09/26 WK2 Group Meeting

Location	ANU Engineering building	
Date	09/26	
Time	21:00-22:00	
Attendees	Derek Tan, Lily Zhang, Jessica Ying, Andre Olivier, John Xu

- 1. Collect feedback for our system from expert from Sensitar (John Xu)
- 2. Collect some data that is possible to use to simulate the whole process.

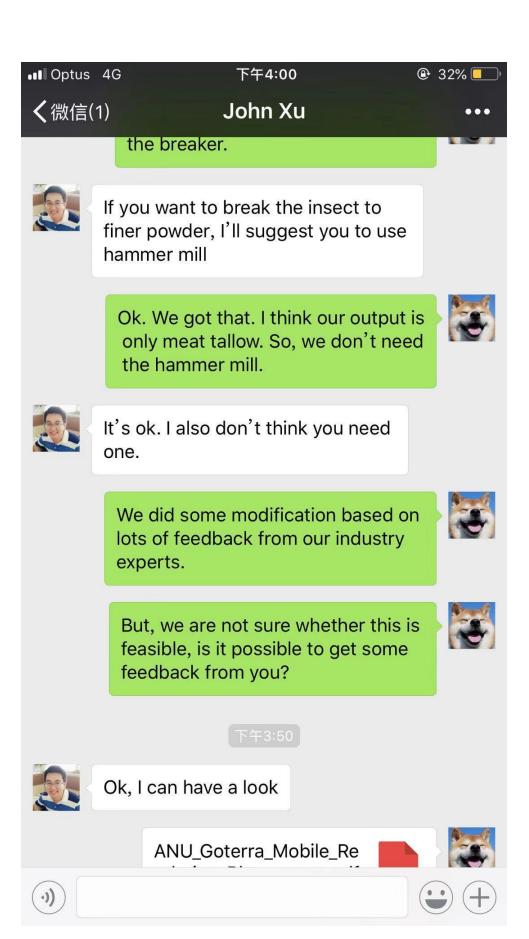
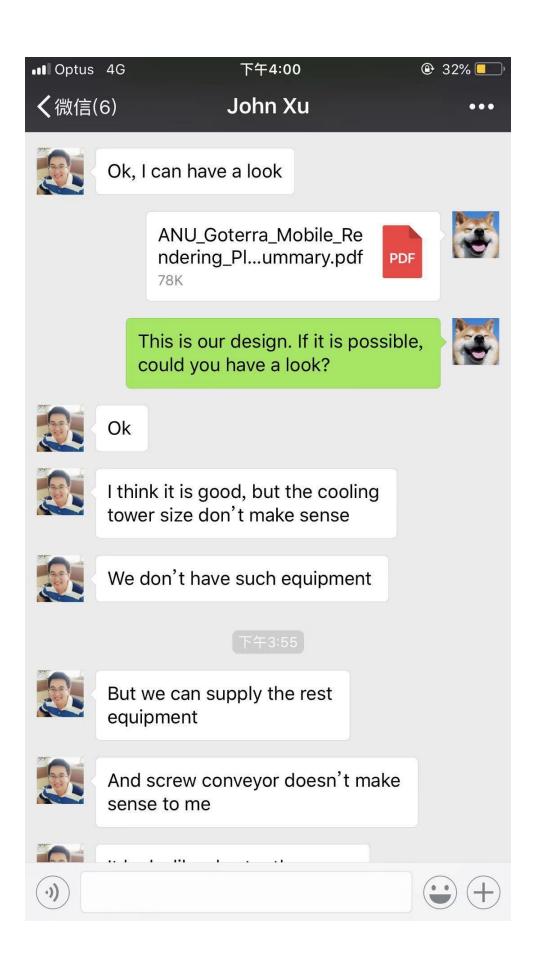
But, we are not sure whether this is feasible, is it possible to get some feedback from you?

But we can supply the rest equipment

And screw conveyor doesn't make sense to me

It looks like shorter than ours

For the cooling tower, we found one online which is smaller than yours. But it has similar capacity.

Do you mind have a look?

We are assuming the capacity is the key parameters for the cooling tower.
